These errata apply **ONLY** to Spartan-3 XC3S5000 FPGAs, including both production devices and engineering samples. These errata **DO NOT** apply to any other Spartan-3 FPGA. If using a different Spartan-3 FPGA, check for errata specific to that device.

Table 1: Spartan-3 XC3S5000 FPGAs Affected by This Errata

Figure 1: Spartan-3 FPGA from UMC 300 mm facility with “GQ” Fabrication/Process Code Marking

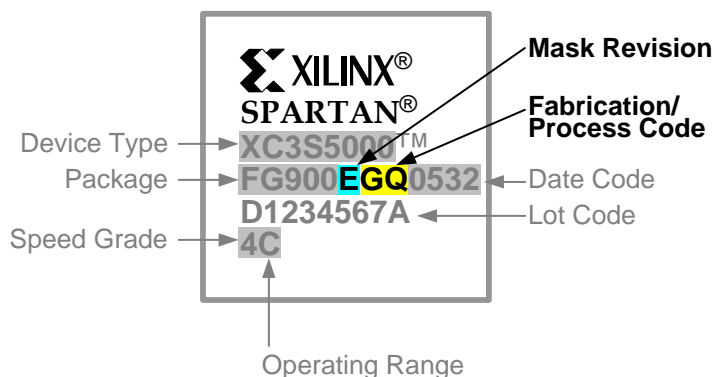
This issue only applies to those designs using the Readback feature on the XC3S5000 FPGAs shown in [Table 4](#) with a “AGQ” Fabrication/Process Code marking or a date code prior to “0532”, as shown in [Figure 1](#).

The readback feature is not available for the devices indicated in [Table 4](#).

XC3S5000 FPGAs with an “EGQ” Mask/Fabrication/Process Code marking and with a Date Code of “0532” or later fully support Readback. XC3S5000 FPGAs ordered using the standard part number (without SCD codes) scheduled for delivery after 15-AUG-2005 automatically include the latest mask revision and Readback functionality.

Figure 2: Example Spartan-3 Package Markings

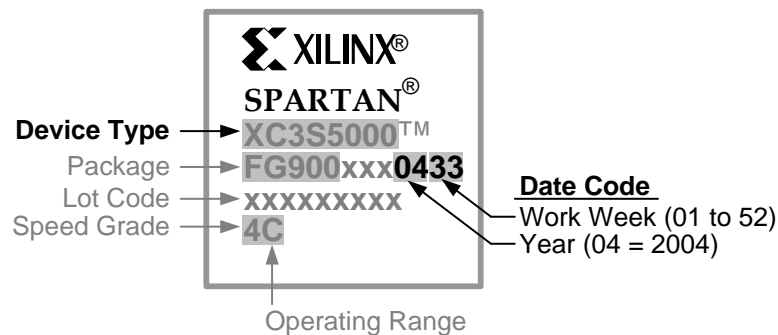
Spartan-3 block RAM internal timing is controlled by settings in the FPGA configuration bitstream. Through yield analysis, new optimal bitstream settings were identified for specific Spartan-3 device types. These new settings improve the block RAM internal timing margin, which consequently improves overall product yield and availability. **These new settings do not affect any timing in the FPGA application**, only internal timing relationships within the block RAM. The specific improved internal block RAM timing path is the relationship between the write-enable timing and the input latch-enable timing.

These new bitstream settings are now the default settings starting with Xilinx 6.3i, Service Package 1, available for download from the Xilinx web site after September 13, 2004. XC3S5000 FPGAs are tested using these new bitstream settings beginning with date codes “0433”, corresponding to Work Week 33 of 2004. [Figure 2](#) shows an example top marking for a Spartan-3 FPGA. The relevant fields to identify an affected device are highlighted and include the **Device Type** and the **Date Code**.

**Please regenerate any Spartan-3 FPGA configuration bitstreams** created using software versions prior to Xilinx ISE 6.3i development software, Service Pack 1. By updating the bitstream, the application can use any existing or future production Spartan-3 FPGA device.

Figure 3: Enable User Editing in FPGA Editor

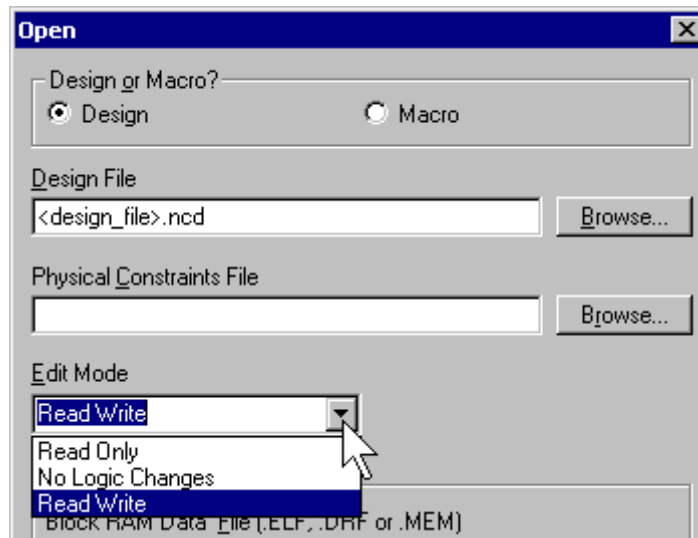
The DCM automatically compensates for process, voltage, and temperature (PVT) changes and consequently it periodically updates its delay tap settings. The rate at which the update occurs is controlled by an internal attribute called FACTORY\_JF. Xilinx has identified an optimal FACTORY\_JF setting value (FACTORY\_JF=8080). Other settings may potentially fail to track properly over process, voltage, and temperature.

Without using the optimal settings, the DCM could potentially, with low probability, fail to assert the LOCKED output, could lose lock, or could produce erroneous clock outputs.

The new optimal settings are applied starting with Xilinx ISE 8.2i. If using an earlier version, modify the new FACTORY\_JF=8080 settings on each DCM instantiated in the design. [Table 6](#) shows the best available options to update the DCM settings, depending on current design status.

- Invoke the FPGA Editor. On Windows PCs, select **Start** → **Xilinx ISE 6** → **Accessories** → **FPGA Editor**.
- Select **File** → **Open**. Select the \*.ncd file for the completed design. Set the **Edit Mode** to "Read Write" mode as shown in [Figure 3](#).
